**VALUE ENGINEERING STUDY
OF
*FALL LINE FREEWAY***

**Atlanta, Georgia
January 24-26, 2006**

**Prepared by:
*VE GROUP, L.L.C.***

**In Association With:
GEORGIA DEPARTMENT OF TRANSPORTATION**

AS PROPOSED PAVEMENT DESIGN

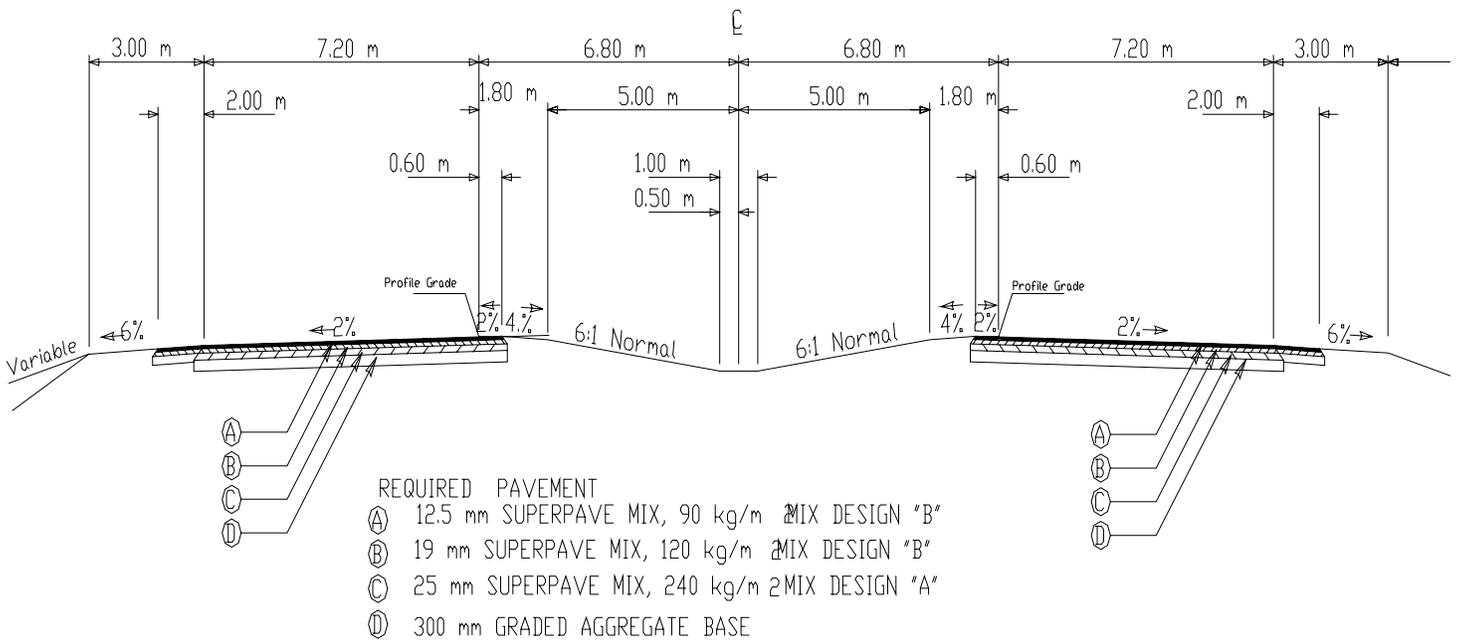
The proposed surface course calls for 12.5 millimeters surface course as shown below.

AS PROPOSED

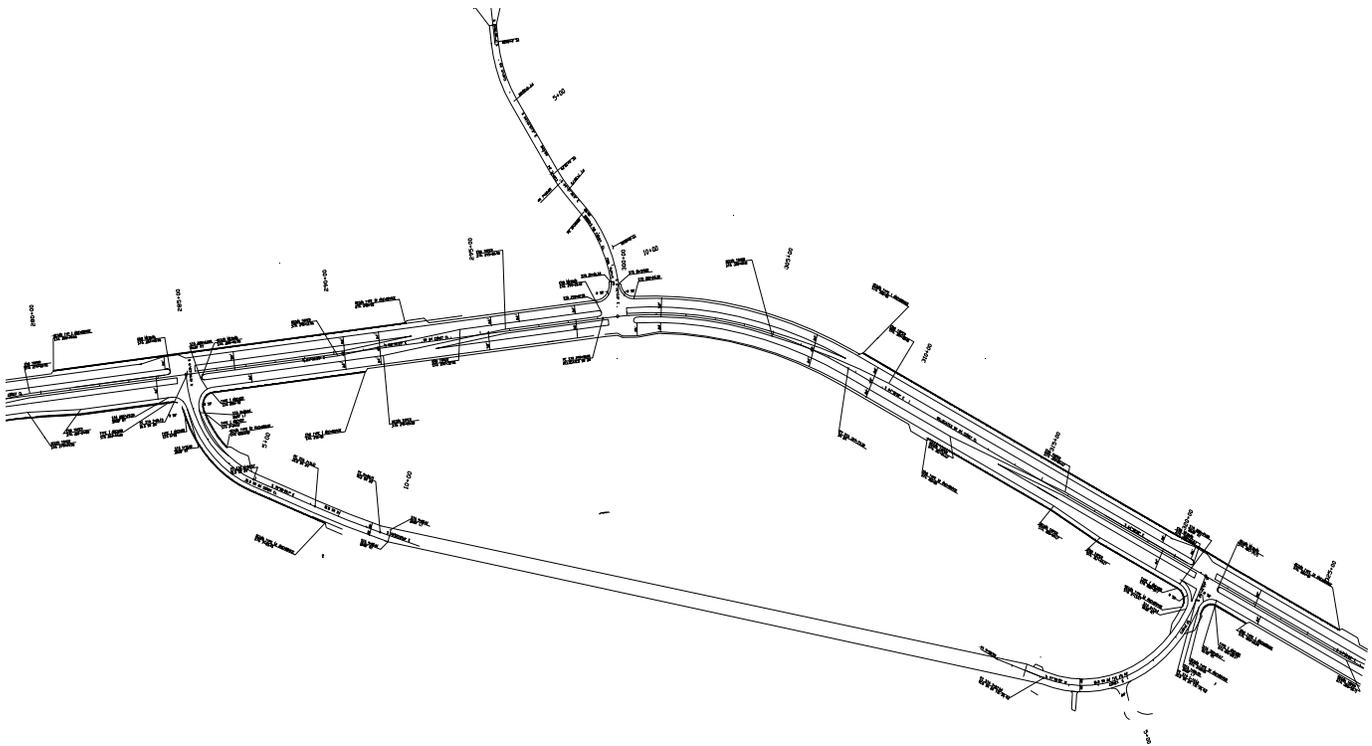
The proposed design for the connecting Brooks Road/CR 6 and the old alignment of SR 24 calls for 3 "T" intersections as shown below.

Value Engineering Alternative: Extend and/or realign Brooks Road/CR 6 to connect to the Old SR 24 alignment and cul-de-sac both ends of Old SR 24.

AS PROPOSED PAVEMENT DESIGN

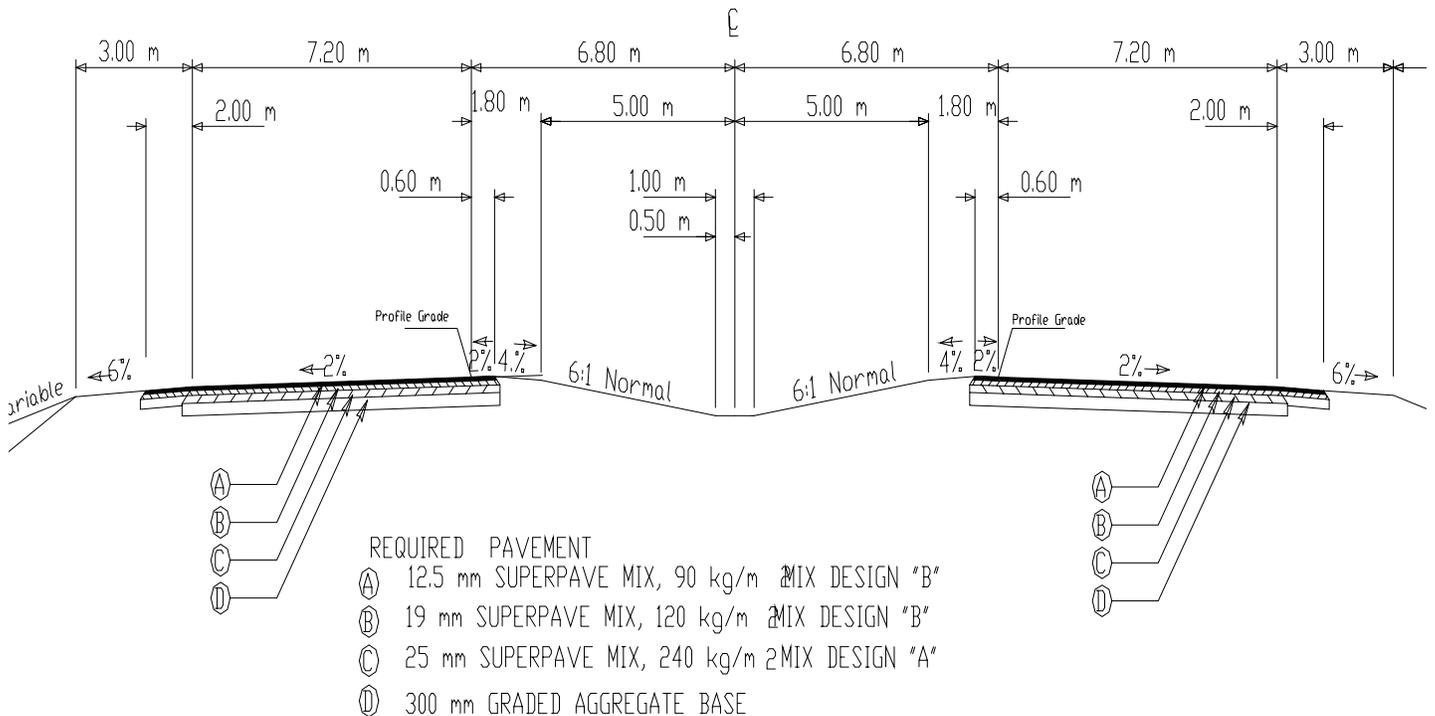
The proposed surface course calls for 12.5 millimeter surface course as shown below.

Value Engineering Alternative: Change 12.5 to 9.5 inches of surface course.
